## Industry/TSTF Standard Technical Specification Change Traveler

### Revise SR frequency for Minimum Temperature for Criticality

NUREGs Affected:  1430  1431  1432  1433  1434

SR 3.4.2.1

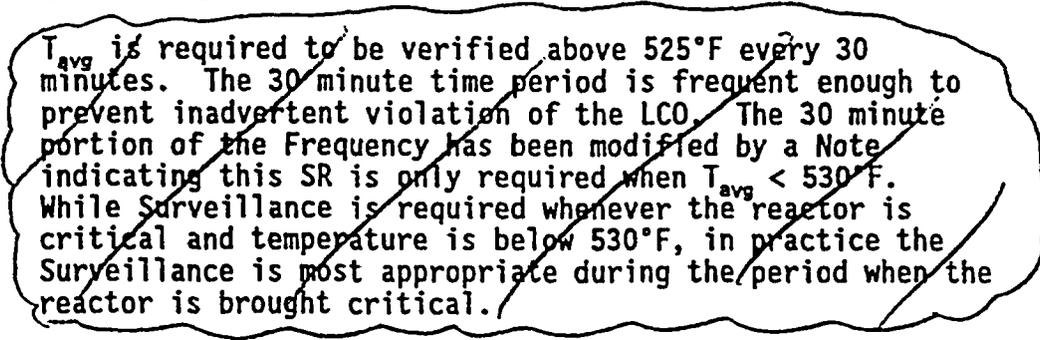
~~$T_{avg}$  is required to be verified above 525°F every 30 minutes. The 30 minute time period is frequent enough to prevent inadvertent violation of the LCO. The 30 minute portion of the Frequency has been modified by a Note indicating this SR is only required when  $T_{avg} < 530^\circ\text{F}$ . While Surveillance is required whenever the reactor is critical and temperature is below 530°F, in practice the Surveillance is most appropriate during the period when the reactor is brought critical.~~

INSERT 1 (B&W)

RCS loop average temperature is required to be verified at or above 525°F every 12 hours. The SR to verify RCS loop average temperatures every 12 hours takes into account indications and alarms that are continuously available to the operator in the control room and is consistent with other routine Surveillances which are typically performed once per shift. In addition, operators are trained to be sensitive to RCS temperature during approach to criticality and will ensure that the minimum temperature for criticality is met as criticality is approached.
